Preserve the Dunes, Inc. 12/18/97

Application to mine the Taube Road Extension in Hagar Township was made under the 1994 Sand Dune Mining Statute. Section 63702 of the statute allows mining in a Critical Dune Area only if (a)the operator had been mining the site prior to July 1989 or (b)the operator had been mining or permitted to mine an adjacent property in a Critical Dune Area and prior to July 1989 owned the property for which the amended permit is being sought. **The law prohibits new mining operations in Critical Dune Areas.** The Taube Road Extension includes land in a Critical Dune Area. The Nadeau Site is not in a Critical Dune Area. Therefore the Extension is a new mining operation in a Critical Dune Area. Section 63702 does not allow an operator to come from an area outside the Critical Dune Area and by amendment begin mining in a Critical Dune Area.

DEQ (Fitch,Whitener, Daniels) 2/10/98

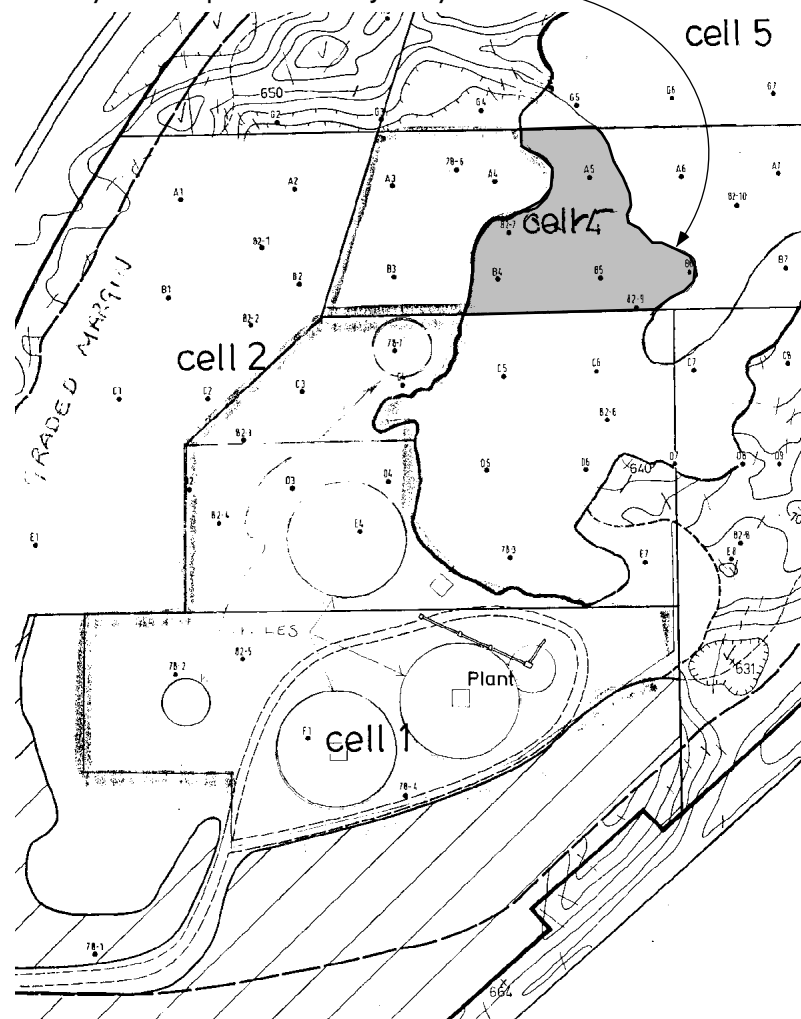
Grey area shows portion of Cell Unit 2 (about 6.20 acres) originally under water or "reclaimed" that was exposed bare sand in January 1998. The base for this illustration is the plan attached to the September 8, 1992 PCUMRP amendment request that TechniSand submitted to move 2 acres from Cell Unit 2 to the Plant Site.

- b. **Cell 2** was revegetated with grass along the west slope. A road runs through the cell. By amendment part of the cell was added to Plant Area. The eastern portion of the cell had been underwater. That portion is no longer under water and is raw sand. **Therefore, it must be considered active.**
Though years have passed since the grass was planted, still no trees and shrubs have yet been planted.

- b. **Cell Unit 2:** The northern reject sand stockpile within the plant site area has transgressed into the cell unit approximately 10 feet along the east side of the haul road. This area will be pushed back and diked and any disturbed area will be planted with marram grass during the fall 1998 planting season. The cell unit has been planted with grasses and woody species. The woody species have been planted as cuttings, seedlings, and seeds. The fast growing hybrid poplars are currently 10 to 20 feet high on the upper slopes of this cell unit, while the pines and oaks are still only one to two feet in height. The Progressive Cell Unit Mining and Reclamation Plan (PCUMRP) does not state a planting density for the woody species but it has never been the intent to restore all areas to a dense forest environment.

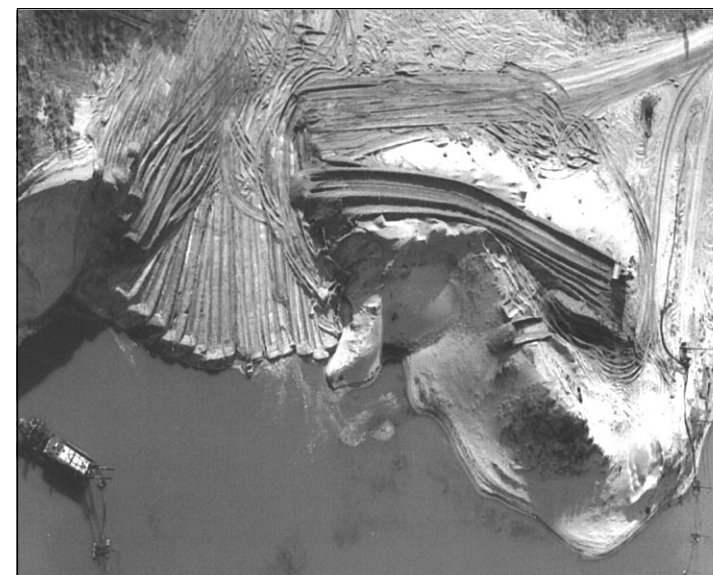
- d. **Cell Unit 4:** We are pleased that the MDEQ will now require TechniSand to comply with the permit conditions in this instance. However, **the area of the violation is 2 1/2 acres, not one acre.** See plan to left.

- d. **Cell Unit 4:** There is a small portion in the western part of this cell unit, approximately one acre in size that has been invaded by the northern reject sand stockpile from the plant site area. This area was previously in open water and will be re-excavated as a shallow wetland area and the stockpile will be diked to prevent future incursions.

Cell Unit 6 being dredged and bulldozer pushing sand from Cell Unit 3 into Cell Unit 6 in November 1997.

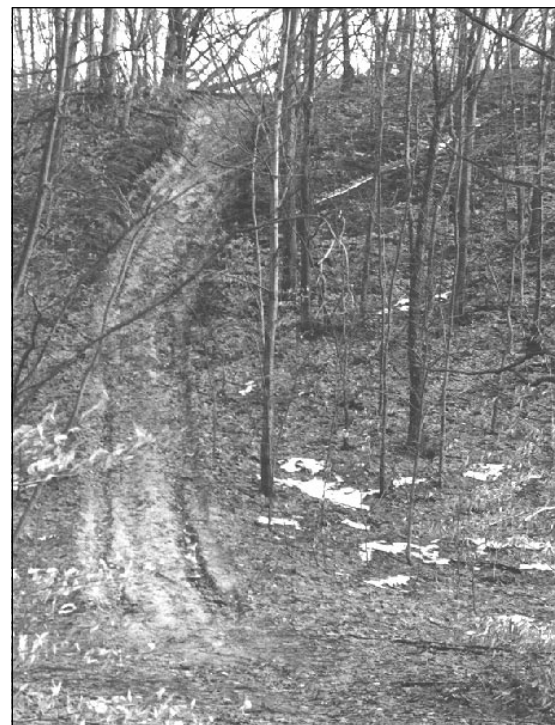
- c. **Cell Unit 3:** The response ignores the fact that **Cell Unit 3 was being mined in November** as shown in the photograph on this page. There are large bare patches that have never been replanted and slopes that have not been regraded.

- c. **Cell Unit 3:** This cell unit is in interim status. At the time it was placed in interim status all of the conditions for interim status were met; however, because of the difficult growing conditions which exist within sand dunes, not all of the grasses that were originally planted have survived and supplemental planting on the lower slopes is required. This is not an uncommon situation and the cell unit will remain in interim status until all conditions for full release are met.

Abandoned mining equipment in April 1998 after being moved to the Plant Area with 20 foot transgression into Cell 1.

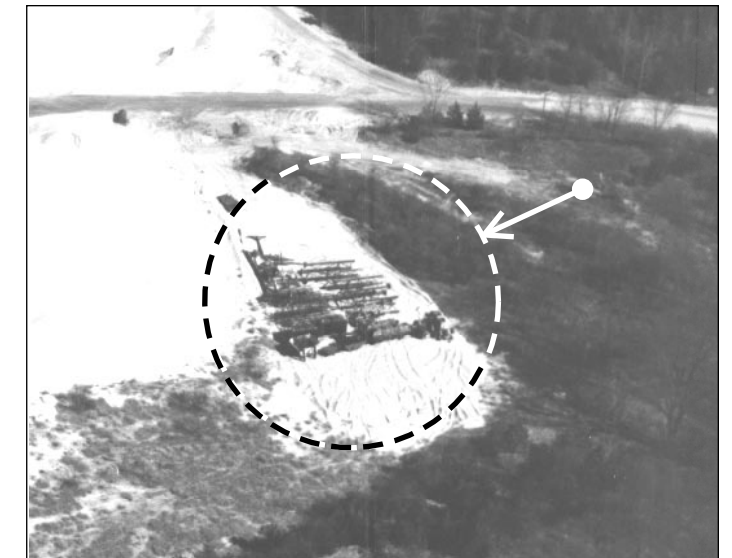
3. **The MDEQ was in violation of its own regulations and the conditions of the permit by permitting a haul road through an inactive cell.**
4. This response underestimates the extent of the violation that continued to exist through March of this year. Compare the two aerial photos below. They indicate the location of the equipment in mid-February, 1998 and in early April, 1998. This violation has now been eliminated.

Response: As stated earlier, the DEQ agrees there was a minor boundary line violation between Cell Unit 1 and the plant site, and the mining equipment has been relocated to completely within the plant site area.

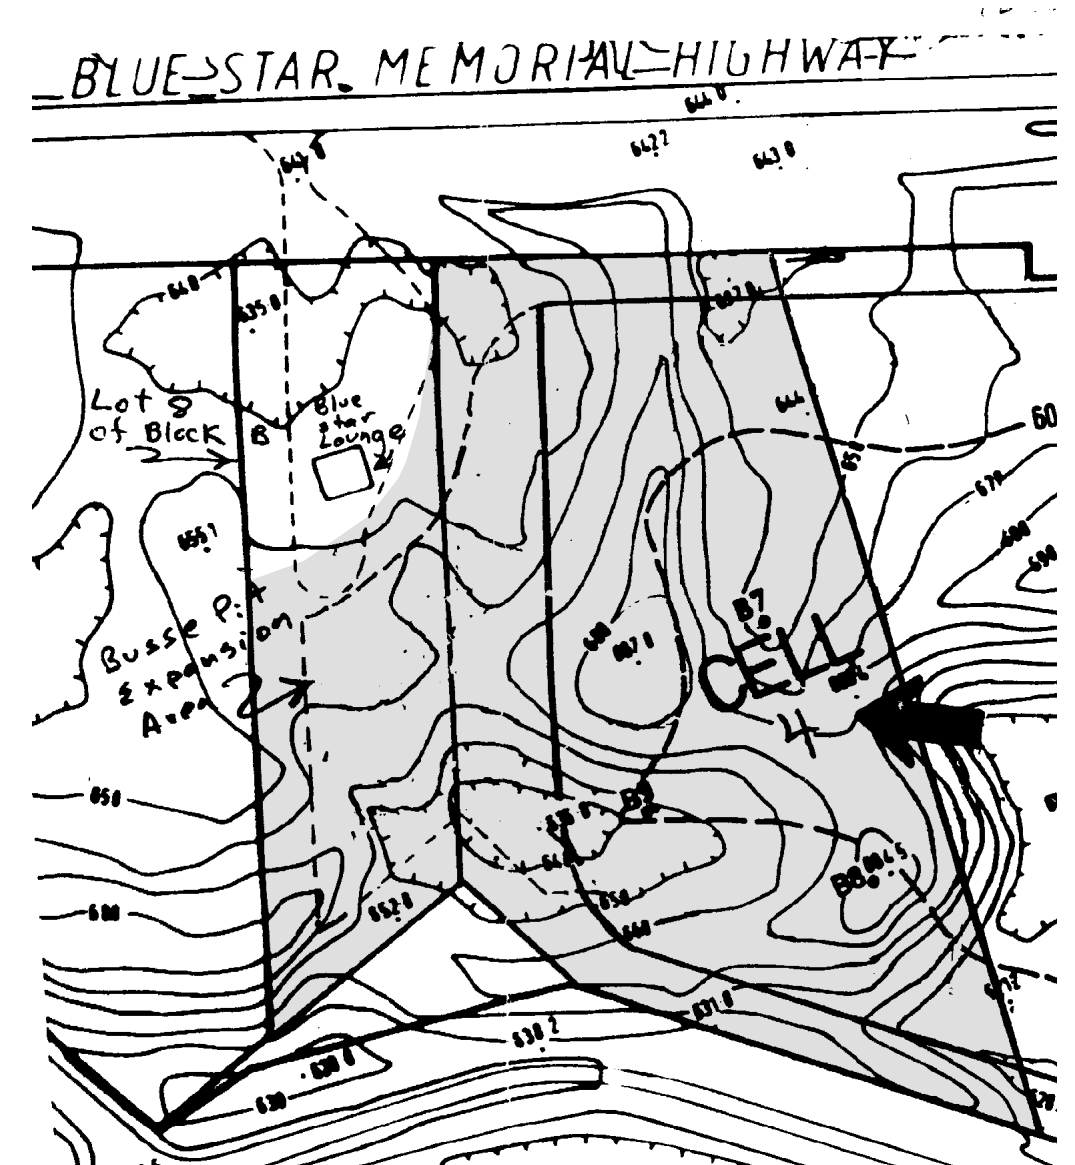
1. "... the area of Cell 4 is actually between 10.20 and 10.41 acres - exceeding the largest cell permitted by law. ... No exception in the buffer width should have been made.

1. We are not convinced. What was measured? How was it measured? We have digitized the area from a 1"=200' plan of the area attached to the Permit and furnished to us by the MDEQ under the FOIA. The area of Cell Unit 4 including a 50' buffer area as shown in the plan below is 453,833 square feet or 10.42 acres. If we use the area permitted by the mineral rights agreement, the area is 458,586 square feet or 10.52 acres. We continue to maintain that **the area of cell unit 4 was larger than the maximum permitted by law.**

Response: In order to obtain a third party determination of the acreage in Cell Unit 4, the DEQ sent the current mining plan to the Department of Natural Resources, Real Estate Division, who conducted their own calculations. The Real Estate Division determined that Cell Unit 4 is 9.8 acres in size.
